Information Quality Incentive

RIIO - an incentive led price control

RIIO Strategy – creating a strong incentive

Figure 1. Draft Determination: DNOs relative to upper quartile

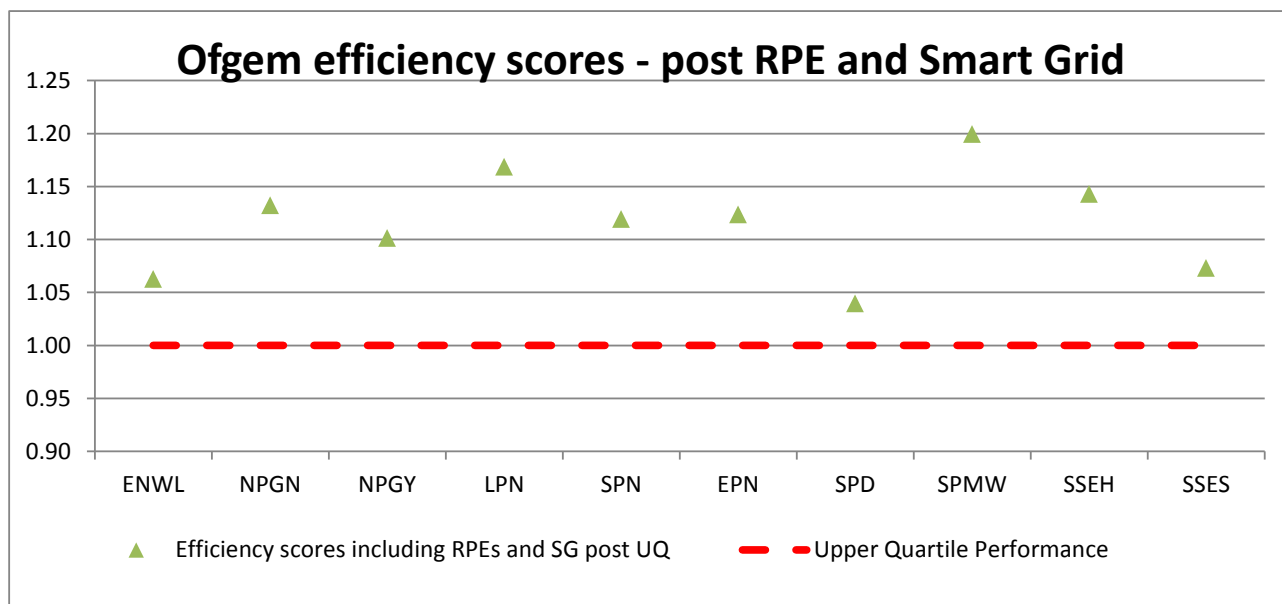
The following graph shows the industry position relative to the determined upper quartile efficiency set by Ofgem in the draft determination. This would suggest that no network is efficient and that there therefore exists a theoretical 'Frankenstein' network at the frontier.

Figure 2. Cost assessment (excl RPEs & Smart): DNOs relative to upper quartile

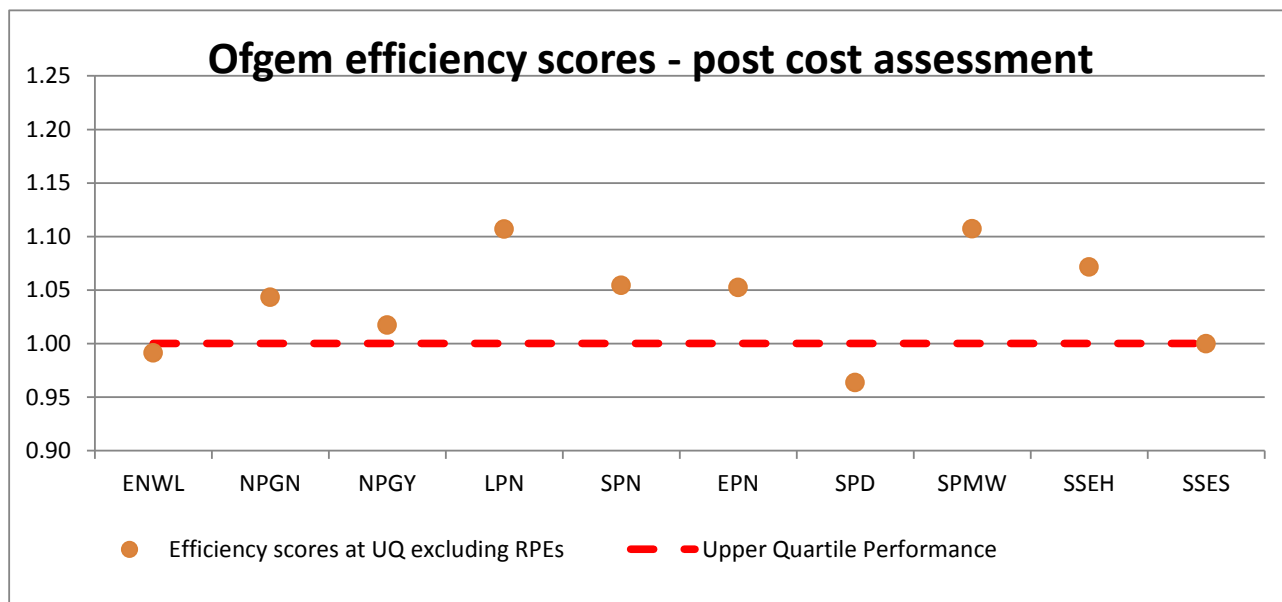
Conversely the following graph illustrates a distribution of efficiency scores based on DNO controllable expenditure which is in line with the expectations of the RIIO strategy.
